Addendum to EIAR Chapter 10 Noise & Vibration

Suir Island Infrastructure Links

Project Name: Suir Island Infrastructure Links
Project Number: 20_071
Report Title: Addendum to EIAR Chapter 10 Noise & Vibration
Filename: RPT-20_071-037A

Issue No.	Issue Status	Date	Prepared by	Checked by
0	Issue for response to ABP RFI	25/09/2024	LW (AWN)	LP

Appendix A - Construction Noise Contour Mapping

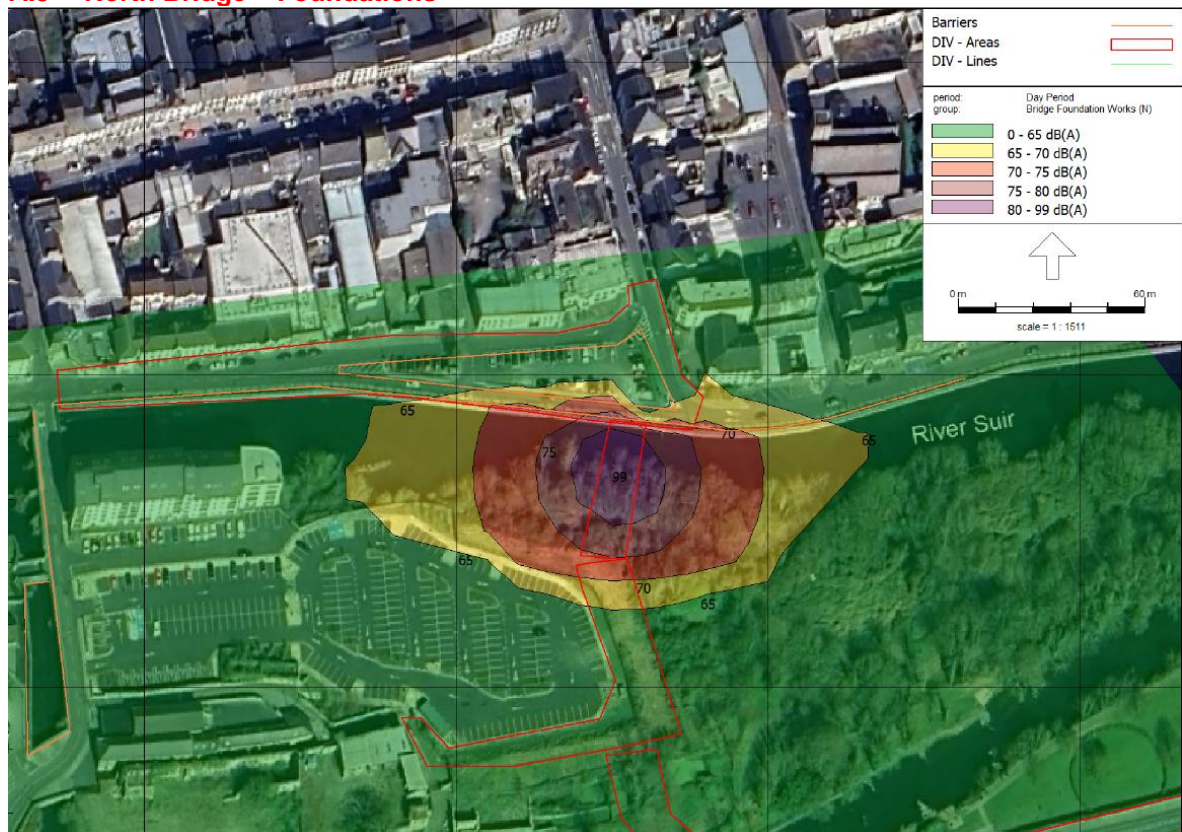
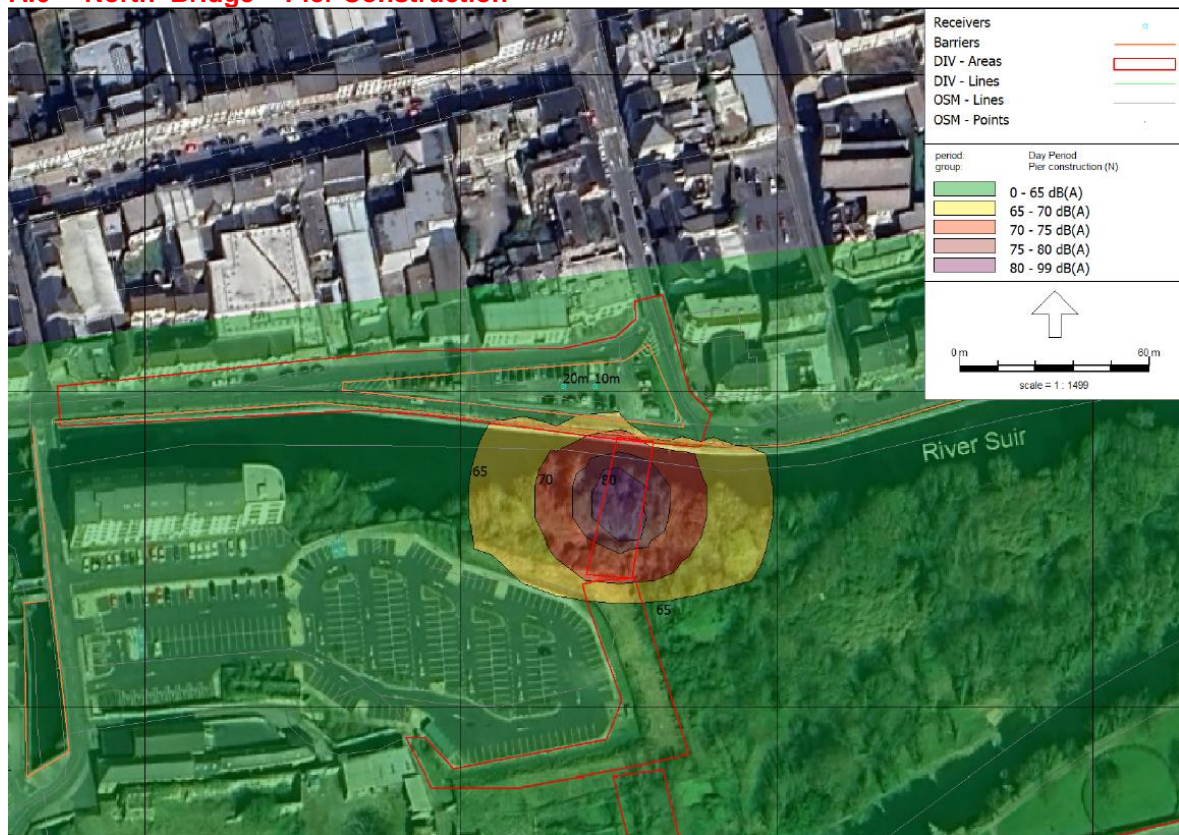
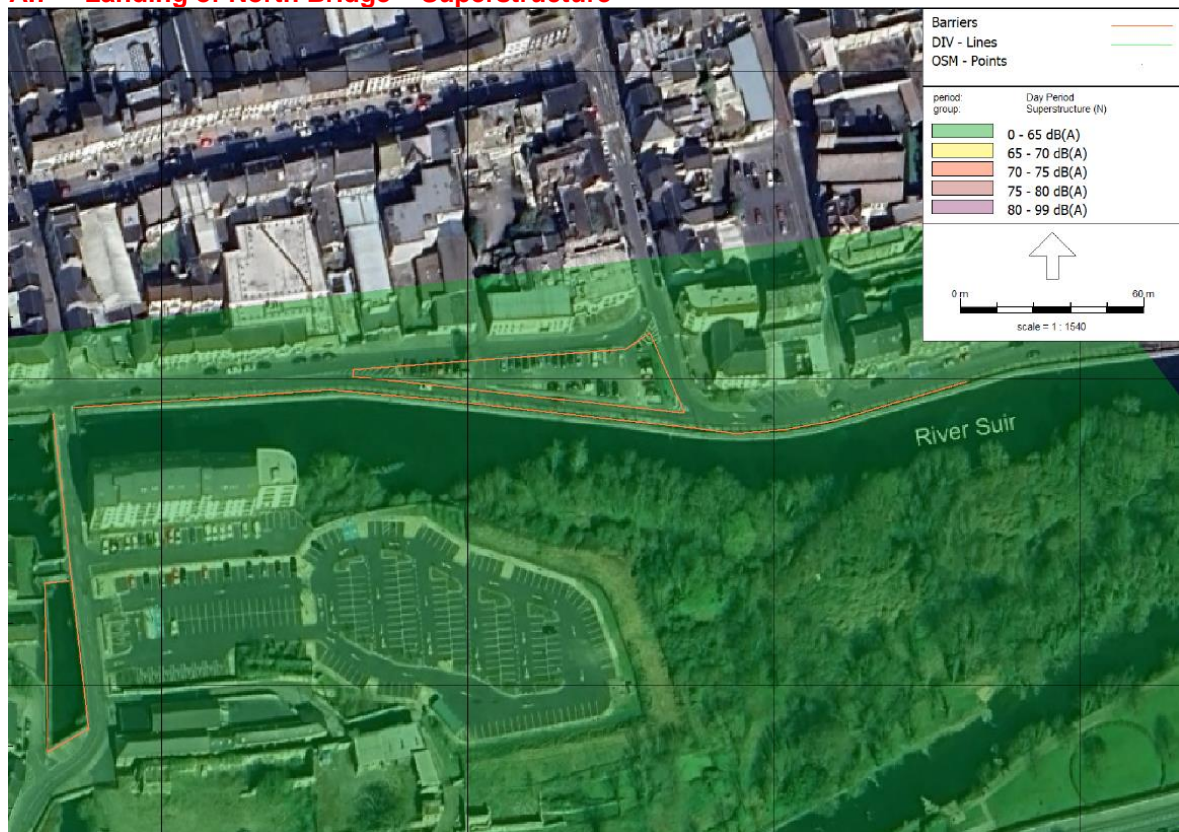
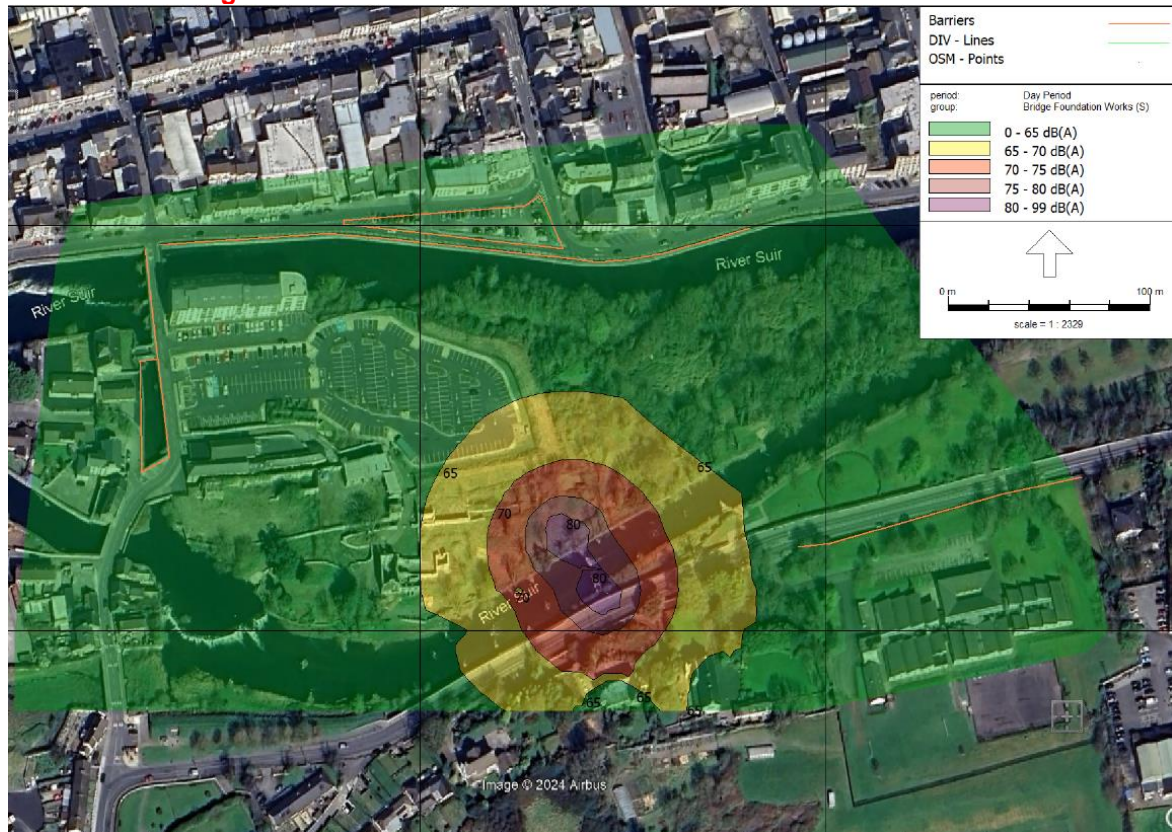
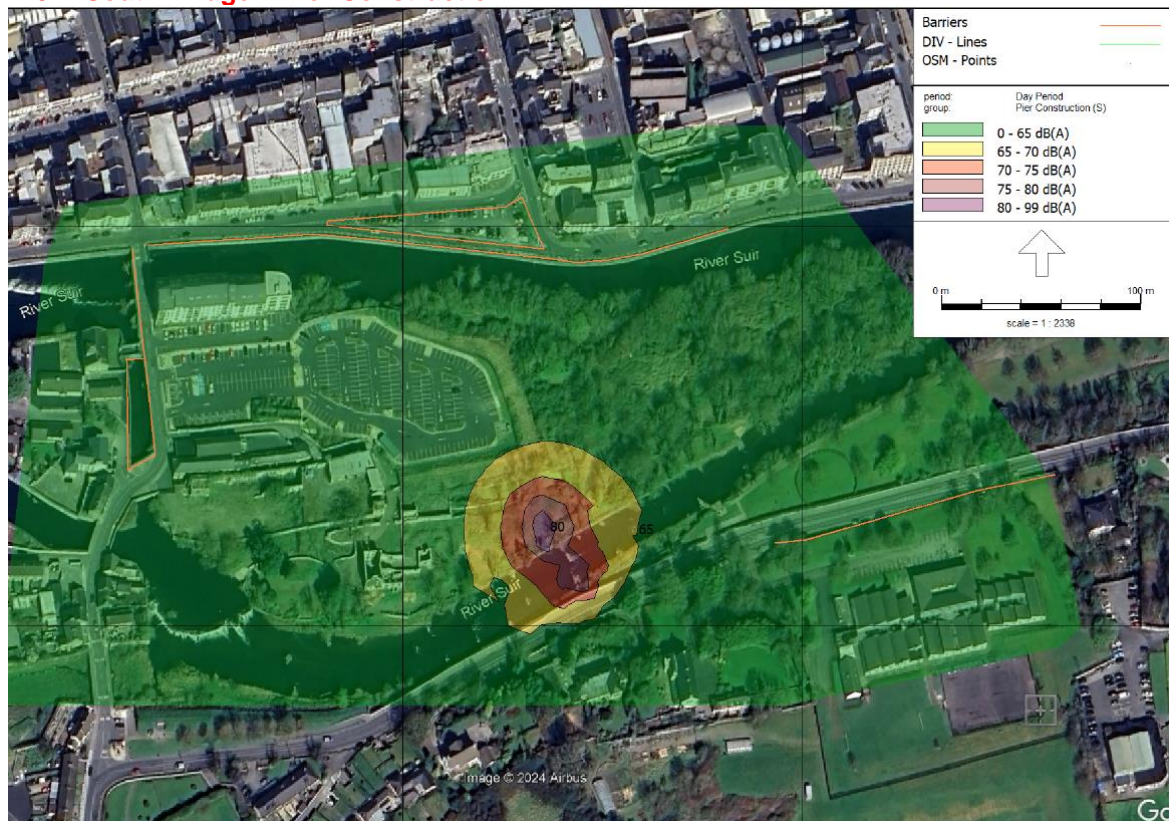
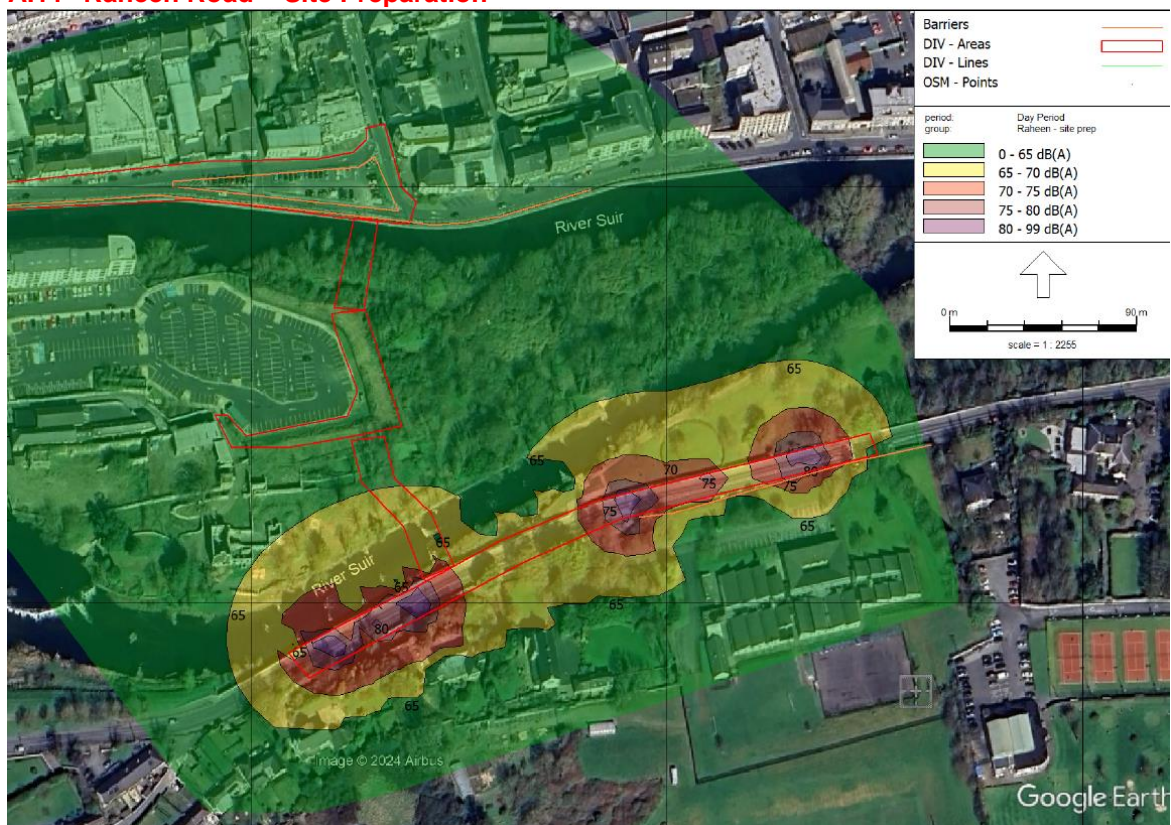
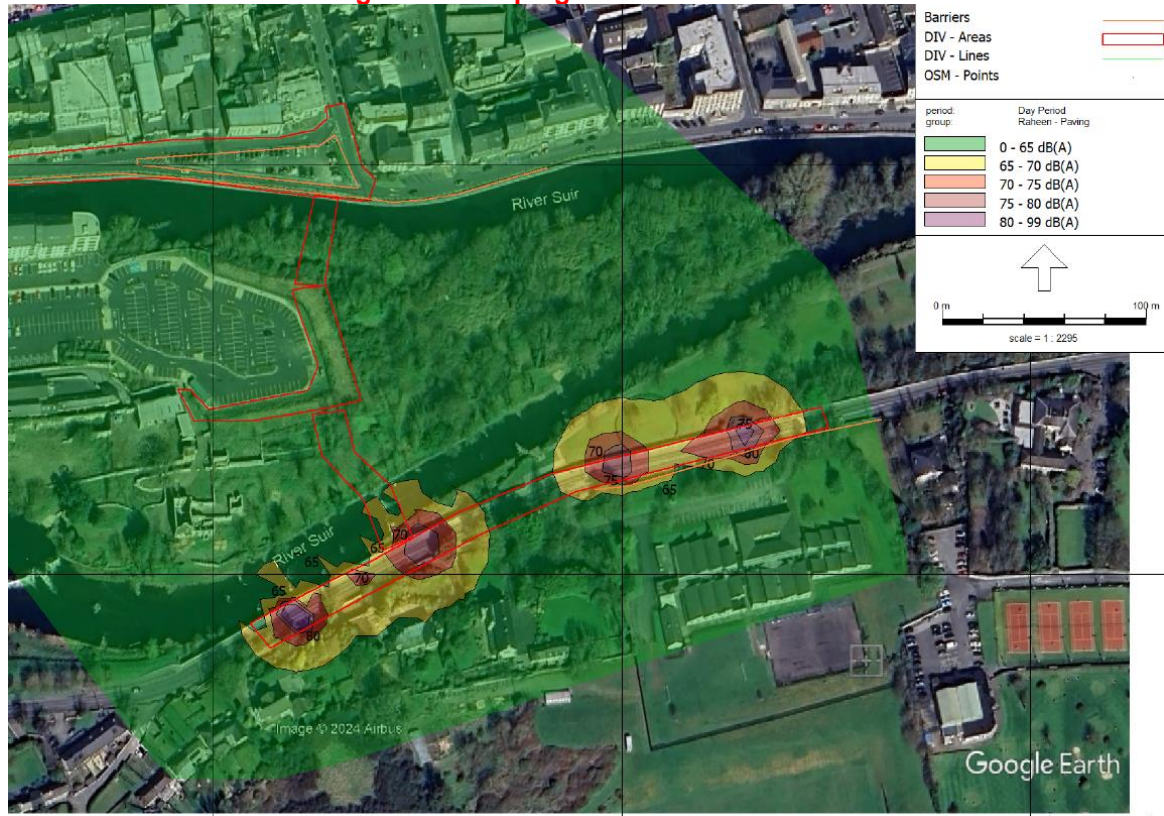
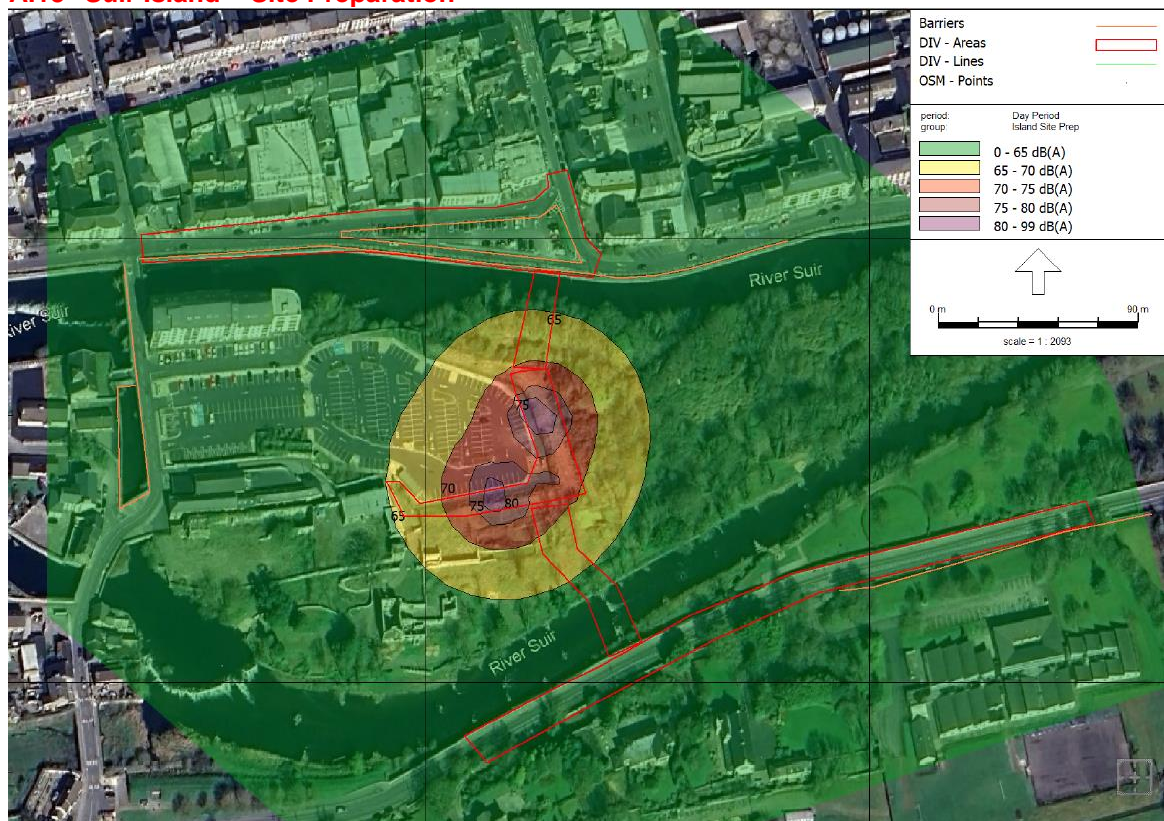
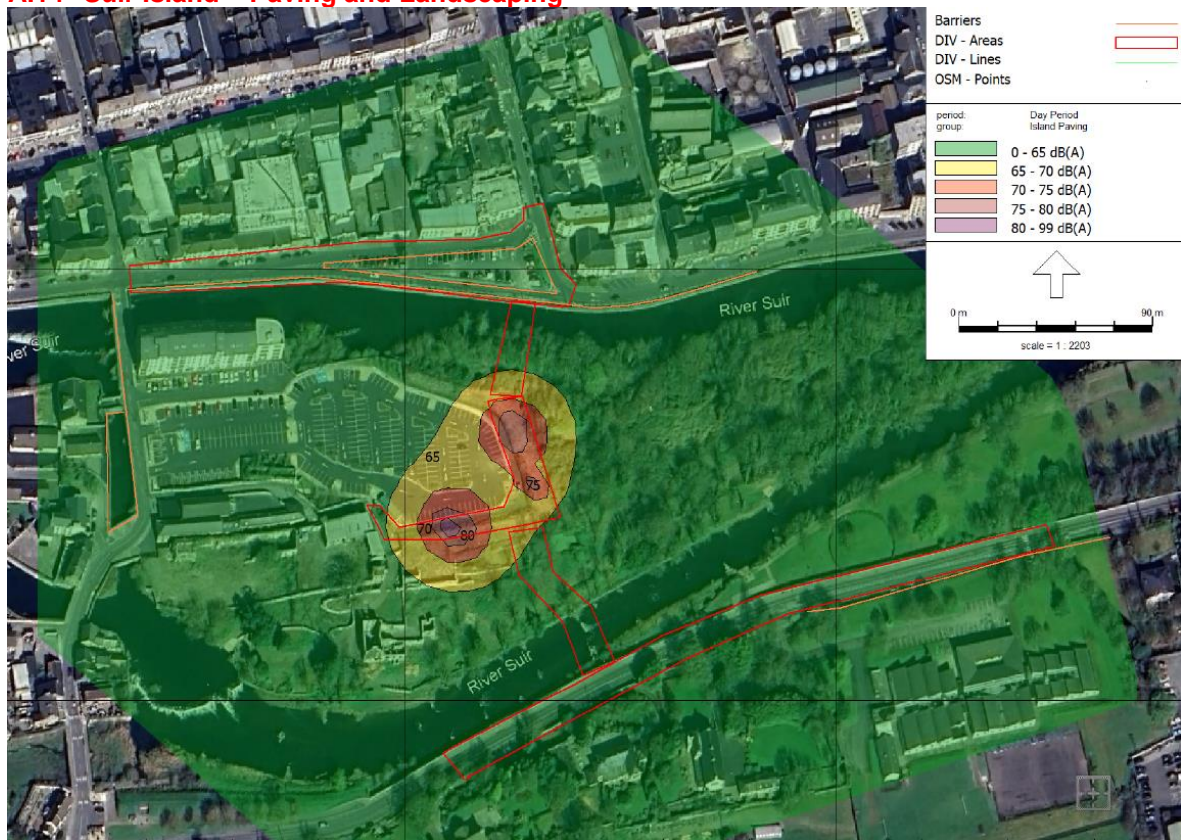
“There EIAR outlines there is a potential for very significant noise impacts to arise at nearest sensitive locations (NSLs) at the construction stage. Mapping should be submitted indicating the expected worst case noise levels arising at the construction stage at noise sensitive receptors in the immediate vicinity of the site (including residential properties at The Quays, Sarsfield Street, Raheen Road), with the application of noise mitigation measures.”

Noise contour mapping (included in Appendix A) has been prepared in response to this item for the construction phases discussed in the EIAR which involve plaza and bridge construction works.

As discussed above, the noise levels illustrated in the noise contour maps are considered conservative and account for the assumed mitigation measures listed above that can be accurately represented in model format. Where noise sensitive locations fall within a noise contour band higher than the assigned construction noise significant threshold, there is potential for a residual significant impact at that location, depending on context.

The results of the modelled scenarios indicate that construction noise levels are highly localised to specific areas of works and will be highest at the façade of buildings immediately adjacent to the works. Construction noise levels reduce significantly beyond the immediate working area and are reduced to within the construction noise significance thresholds at distances beyond 20 to 50m from a working area.
